Product hierarchy no. *				Part no.	SBU	Type / Description	Customer part no.
SBU	PG	PUG	Type				
02	007	001	020070010000002316	See list below	Connector	2565 Appliance Inlet C6	n/a
<small>*SBU (2-digit) / PG (3-digit) / PUG (3-digit) / Type (10-digit)</small>							
List of part numbers affected							
3-104-688		6160.0039		6160.0040		6160.0083	
6160.0100		6163.0015		6163.0020		6163.0021

UL upgrade from UL 498 to UL 60320-1.
Marking for UL rating 7A/125V~ updated.

Product Change Notification					2565 Change of marking		
owner	creation date	release date	released by	change order no	rev	page	D10-052-457
zeierjo	31.03.2021	31.03.2021	muehlema	2020050	C	1 of 1

3 Detailed description of change

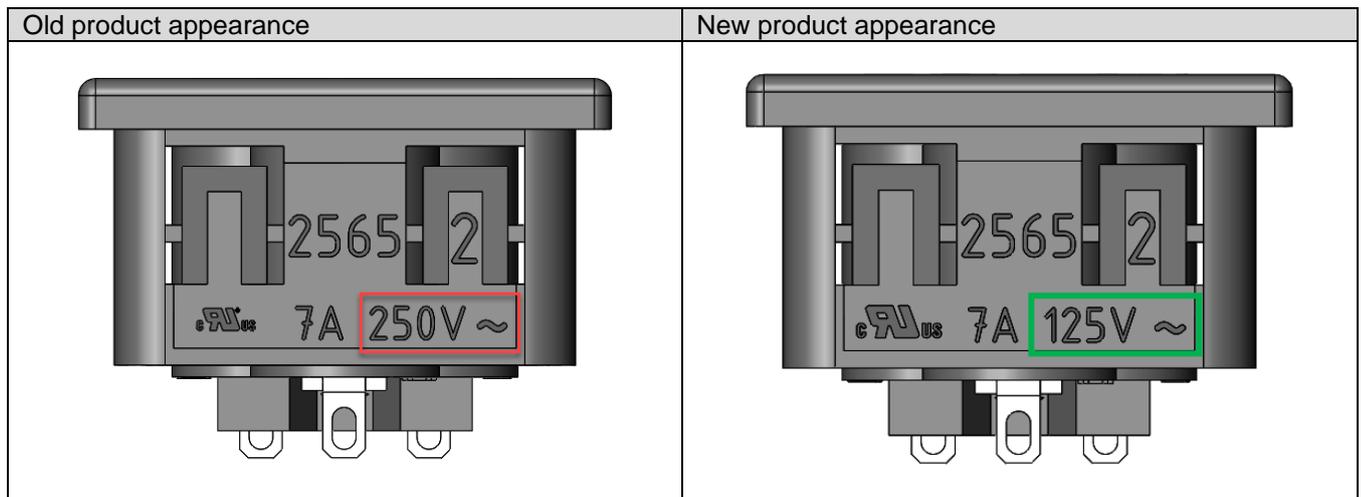
Standards update according to the new UL/CSA 60320-1.

Form	Yes	Change of rating marking.
Fit	No	-
Function	No	-
Manufacturing	No	-
Label	No	-
Packaging	No	-
